Access Compliance Report Public Rights-of-Way (Curb Ramps)

Intersection ID: N/A Main Street: MONROE RD Cross Street: KNICKERBOCKER DR Location: NE **Overall Compliance: No** ADA ID: 0AF39C6574B6 Ramp Type: Directional1 Initial Pass/Fail: Fail **Severity Score:** 1.25

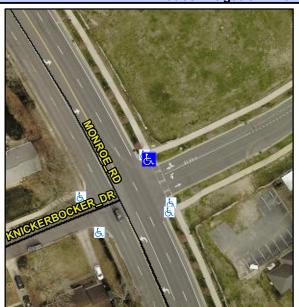
Possible Solutions:	Compli	ance Description
Remove & Replace Entire Ramp.	N/A	Ramp Length (in)
	Yes	Ramp Width (in)
	Yes	Ramp Slope (%)
	No	Ramp XSlope (%)
	N/A	Flare Type LT
	N/A	Flare Slope LT (%)
Surveyor Notes:	N/A	Flare Traversable LT?
N/A	N/A	Landing Length (in)
	N/A	Landing Width (in)
	N/A	Landing Slope (%)
	N/A	Landing X Slope (%)
PROW/ADA:	N/A	Landing Curb? (Y/N)
R304.5.3	N/A	Shared Landing?
	N/A	Gutter Ponding?
	N/A	Gutter Lip Ht (in)
	N/A	Painted X Walk1?
		X Walk 1 Direction
		X Walk 1 Width (in)
		X Walk 1 Slope (%)
		X Walk 1 X Slope (%)
	N/A	Ramp inside XWalk1?
